## EIA Scoping Direction

# DNS CAS-03072-D7X6N7 – Alleston Solar Farm

13/03/2024

**Annex 1 – Predictive ALC Map<sup>8</sup> Grading of unsurveyed area.**

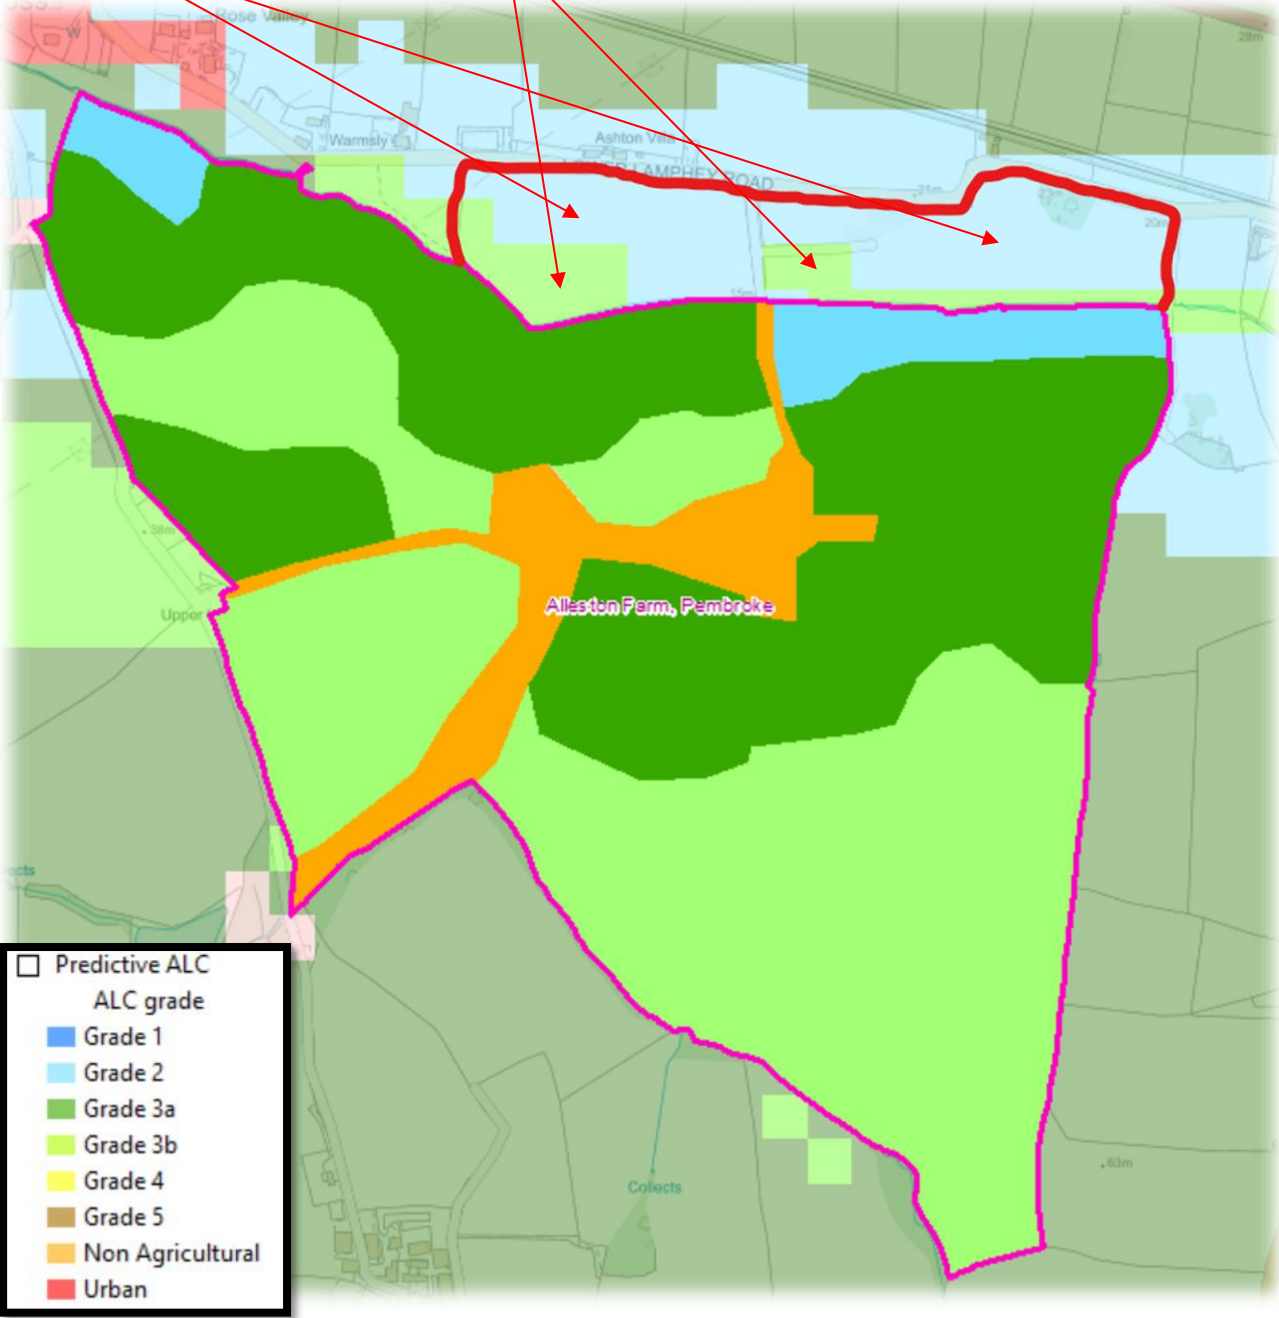
ID	Reference in Scoping Report	Issue	Comment
			<p>The 10 ha unsurveyed area in the north of the proposed site is noted as mainly Grade 2, with some Subgrade 3b on the Predicative ALC map. LQAS note that as per Departmental Guidance, where the Predicative ALC map identifies grades 1,2 or 3a a survey will be required to determine Grades present and in what proportion.</p> <p>LQAS highlight that the proposed application may contain more than 40 ha of BMV agricultural land.</p> <p>The applicant's attention is drawn to LQAS's comments in Appendix 1, regarding how the location and extent of soils on site can inform decisions on infrastructure siting, decommissioning and restoration of the site.</p>
ID.23	6.3	Best and Most Versatile (BMV) agricultural land policy	<p>The applicant's attention is drawn to LQAS's comments in Appendix 1, where it is highlighted that due to the significant area of BMV land within the site, the department expects the ES to include clear evidence of how PPW par. 3.58 and 3.59 have been addressed.</p> <p>LQAS also include in their comments the additional policy context that should be considered.</p>
